SERVICE LETTER SL59 66-12020

2. **Service Letter No.:** SL59 66-12020

3. **Subject:** Torquing of eyebolt

4. **Part/Assembly No.:** 66-12020

Figure 1 - SHOWING MID/REAR STUT AT MLG TRUNION, LHS (View facing aft, from front.

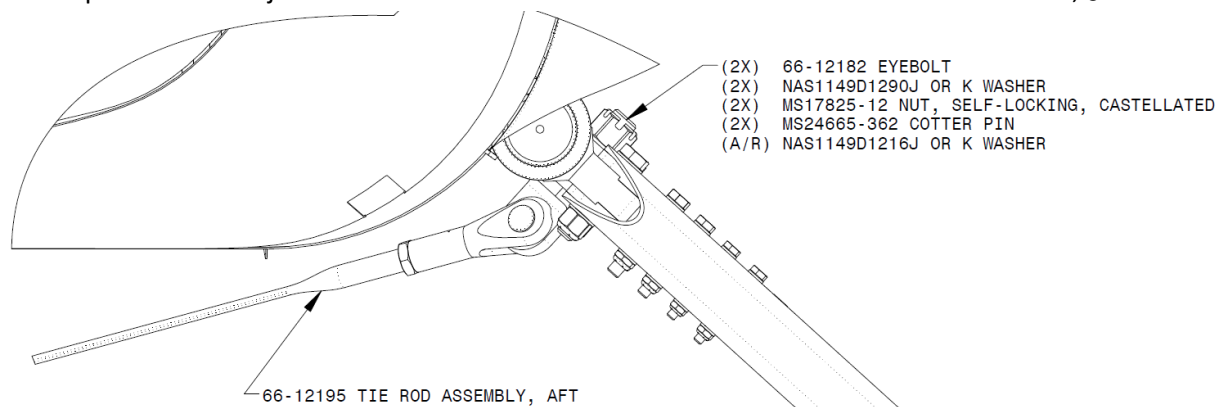
2. **66-12182 Eyebolt Torque Check:** Final torque of the eyebolt nut, MS17825-12, shall be at least 100ft.-lb. and shall not exceed 175 ft.-lb. Existing installations may be re-torqued if the installed torque was less than 210 ft.-lb. Use the following instructions to determine the installed torque.

- A. Remove MS24665-362 Cotter Pin.
- B. Assistant: Firmly secure aft tie rod with an adjustable wrench, or equivalent tool.
- C. Apply torque to the MS17825-12 Nut, starting at the minimum 100 ft.-lb. torque and until a slight turning of the nut is achieved, or a maximum installed torque value of 210 ft.-lb. is met.
- D. If no movement is detected before 210 ft.-lb. is achieved, then REPLACE 66-12182 Eyebolt in accordance with **3. Eyebolt Installation Procedure** below.
- E. If movement is achieved before 210 ft.-lb. is reached, then re-torque the nut 100 ft.-lb. to 175 ft.-lb. and attain cotter alignment.
- F. If 100 ft.-lb. to 175 ft.-lb. final torque cannot be met within cotter alignment, then add NAS1149D1216J or K washer beneath the nut using the instructions below for eyebolt installation.
- G. Install cotter and proceed to **4. Completion**, following.

- Loosen rear tie rods and replace rear eyebolts (66-12182). (Maintain eyebolt alignment using an adjustable wrench or equivalent.)
 - Tighten the eyebolt nut enough to take up slack (Approximately 10-12 ft-lb. torque).

- Tighten tie rod assemblies to remove any bow and assure alignment of eyebolts in clevis slots.
 - Hold the tie rod in place with an adjustable wrench (or equivalent tool) and apply final torque of 100-175 ft-lb. Add one NAS1149D1216J or K if necessary to align cotter hole and stay within maximum torque range. (This washer will produce about ¼ turn (90°) change in nut alignment.)
